Docket Nos. 50-280  
and 50-281

Licenses Nos. DPR-32  
and DPR-37

Change No. 12

CHANGE NO. 12

TS FIG. 6.1-1  
 SEP 19 1973

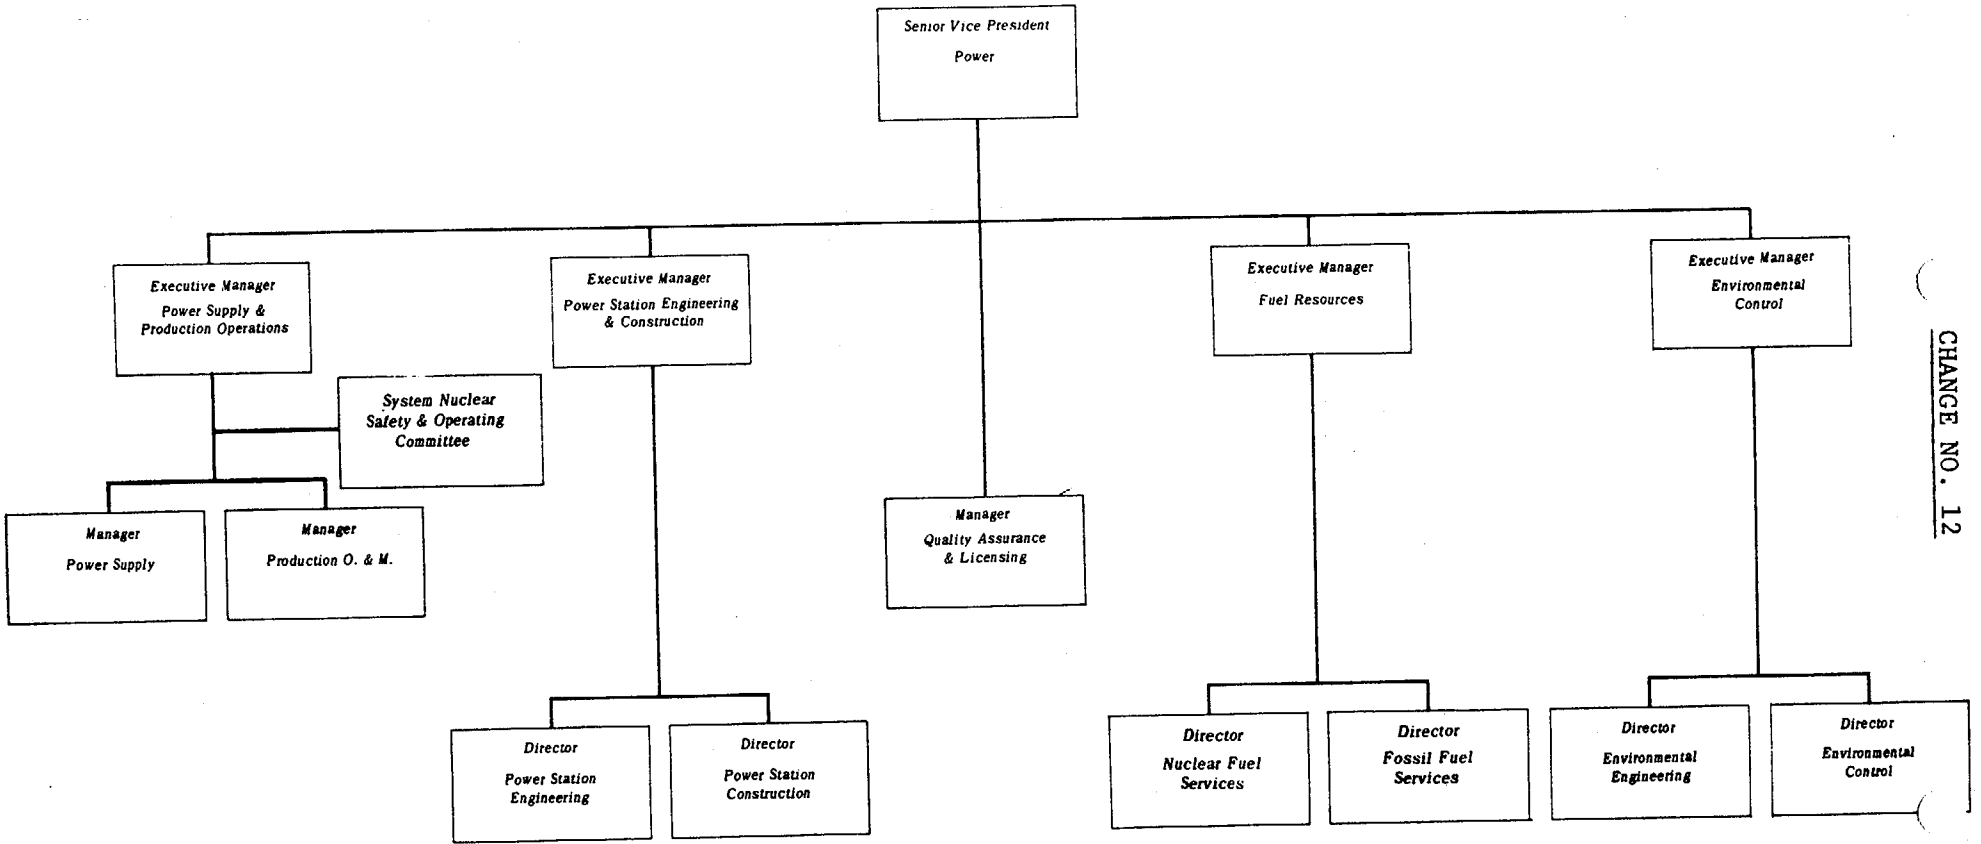
We have reviewed the proposed changes in the Virginia Electric and Power Company management structure which reflect recent reassignments of management and reporting procedures. We have determined that the proposed changes do not adversely affect the management of reactor operations; therefore, the changes are acceptable.

A. The Station Manager shall be responsible for the safe operation of the facility. The Station Manager shall report to the Manager Production Operation and Maintenance. The relationship between this Manager and other levels of company management is shown in TS Figures 6.1-1, 6.1-2, and 6.1-3.

TS FIG. 6.1-4  
 SEP 19 1973

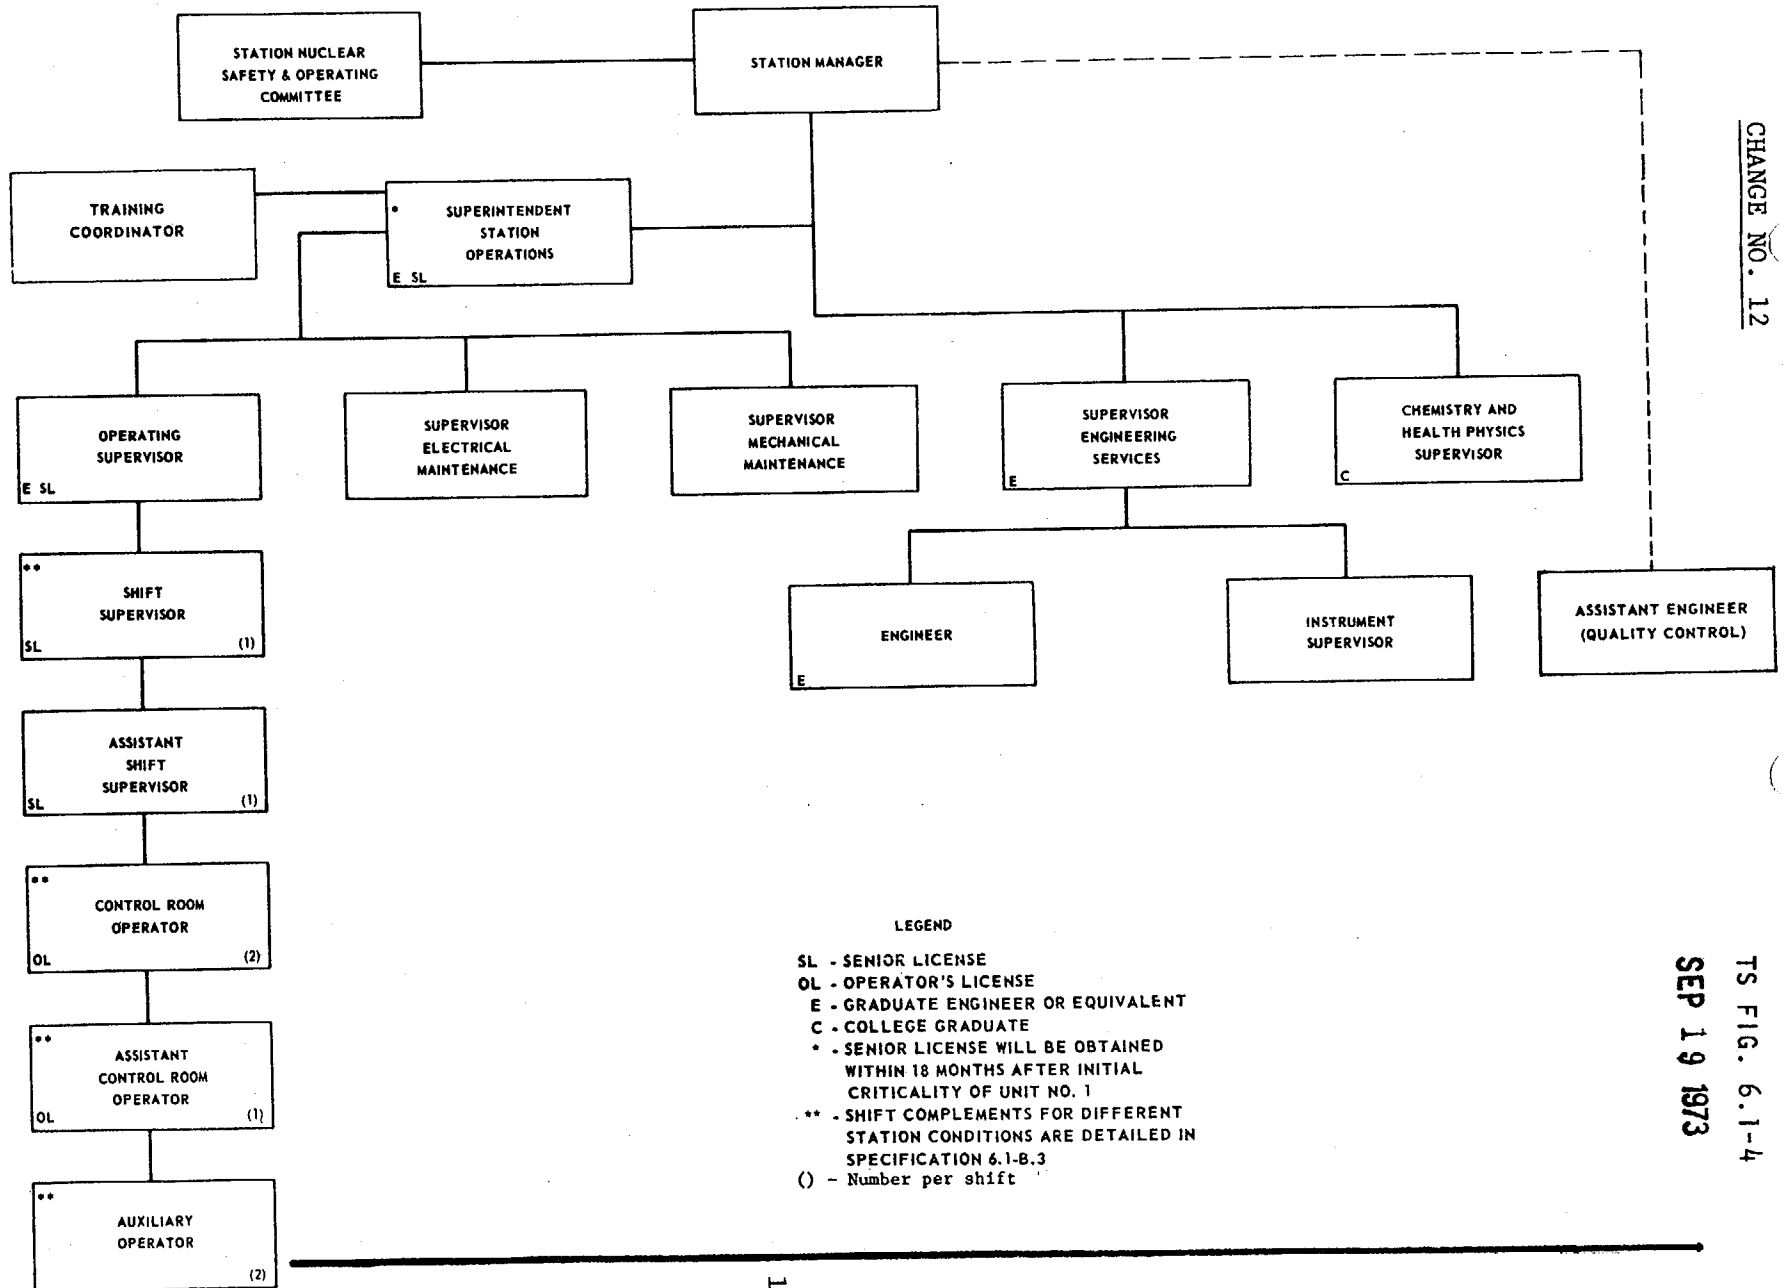
B. The station organization shall conform to the chart as shown in TS Figure 6.1-4.
